the PUD Update #4. This is Update #4. S. Sherrill Smith, Director of Austin Planning & Zoning Department

Figure 4: Portion of Roadway Framework Plan, dated 11/12/15

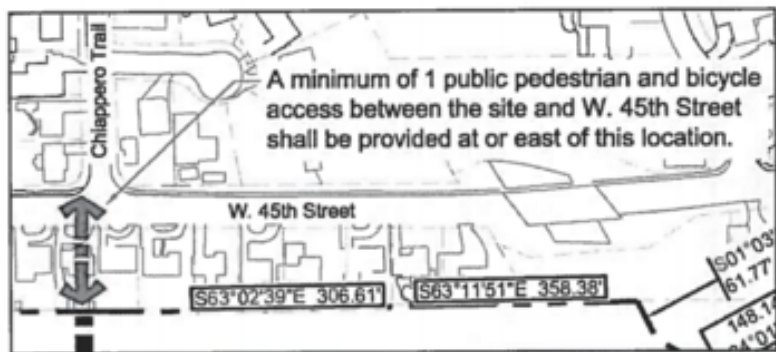
TR5. The correct code section is now referenced in the Code Modification Table. The property at 2627 West 45th Street is not included in the PUD or the TIA and a determination of whether a connection will be made here is not requested as part of the PUD. However, the Parks Plan and Roadway Framework

Plan have been updated to require that, at a minimum, a pedestrian connection be provided to 45th Street either at 2627 West 45th Street or at a location east of that property.
